Product Change Notice (PCN)

PCN Number: PCN-0456971R-01

Product(s) Affected: SJ-4361X-SMT-TR Series (SJ-43614-SMT-TR, SJ-43615TS-SMT-TR, SJ-43616-SMT-TR & SJ-43617-SMT-TR)

PREVIOUS SAME SKY DETAIL / IMAGE	NEW SAME SKY DETAIL / IMAGE

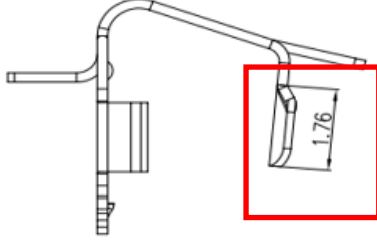
Tooling Adjustment for enhanced functionality and ongoing reliability.

Shortened Lead Contact Area from 2.00mm to 1.76mm for Pins:

- 4 - 12
- 3 - 11

See image on the following page for reference. Please note the change is internal and not reflected on the Same Sky product drawing online. Cosmetic differences may be visible due to new molds and not affect the form fit and function of the product.
